ENGINE - SEAL, NO. 1 STRUT FIRE SHIELD - REPLACEMENT OF - CATEGORY CODE 6 -
MOD.ENG-72-0230

V2500-ENG-72-0230

SERVICE BULLETIN

NO. 1 STRUT FORE SHIELD REPLACEMENT.
Fig.1

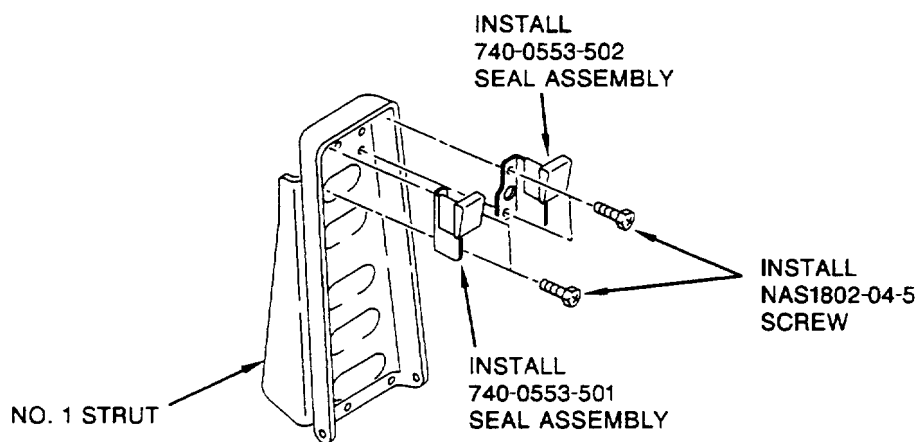
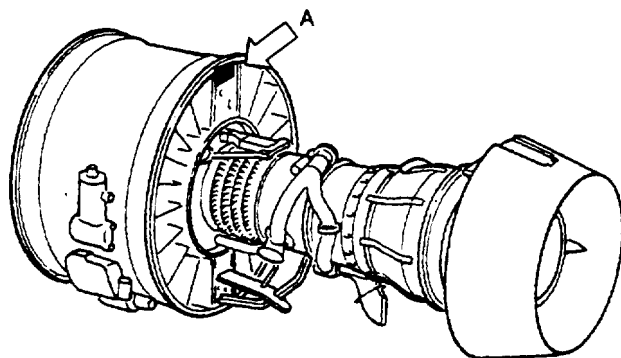
The change introduced by this bulletin is to replace the existing two piece No. 1 strut fire shield assemblies with modified one piece seal assemblies.

- (1) Install 740-0553-501 seal assembly and 740-0553-502 seal assembly on engine No. 1 strut fairing with four NAS1802- 04-5 screws. Tighten screws to a torque of 6-8 lbfin.
- (2) Reidentify the LPC/Intermediate Case module by the approved procedure in IAE V2500 Standard Practices/Processes Manual
